Office Action Summary

Application No.
09/647,700

Applicant(s)
Birgitte Hansen et al.

FIG. 7

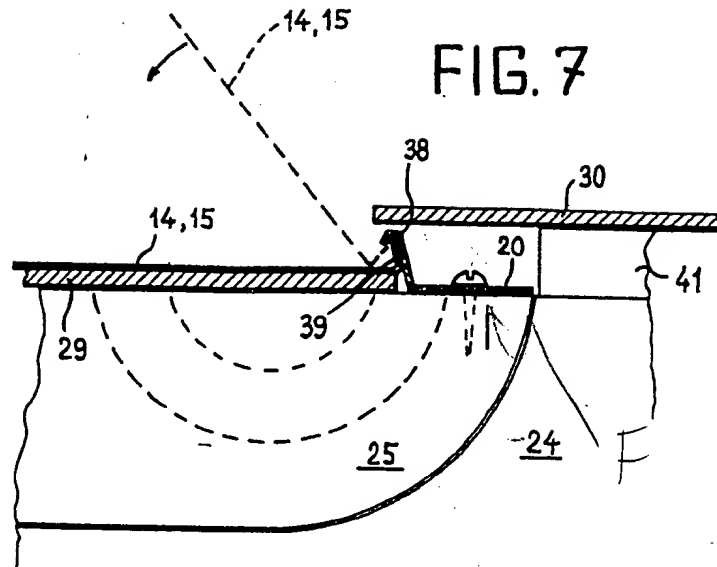
6. In lieu of the 35 USC 112 rejections noted above, claims 1-3,7 and 10 are rejected under 35 U.S.C. 102(b) as being anticipated by Swedish Patent #374578. 374578 discloses the use of a window including top as at (12), a bottom as at (13) and opposing side members as at (10,11) wood profile members covered by a weather shield cover (12,13,14,15), engaging and securing means (20,21); wherein the weather shield cover includes an upper cap (16a-c), an interior glazing profile (41), an exterior cover member (13) and a cap member (14,15) that has an integral bent and hidden engagement means (B), see the marked attachment of Figure 8. Regarding claim 2, the cap (14) pivots, see figure 7. In reference to claim 3, the cap is secured to an upper

portion (12) a lower portion (13) and side portions (15) of an opening (11) by fasteners (F) and securing means (20,21) and (38), see marked attachment. The cap member consists of an upper cap (16a-c) and lower caps (14,15). Regarding claims 7 and 10, the cap is U-shaped with integral bottom (B) and side walls (S).
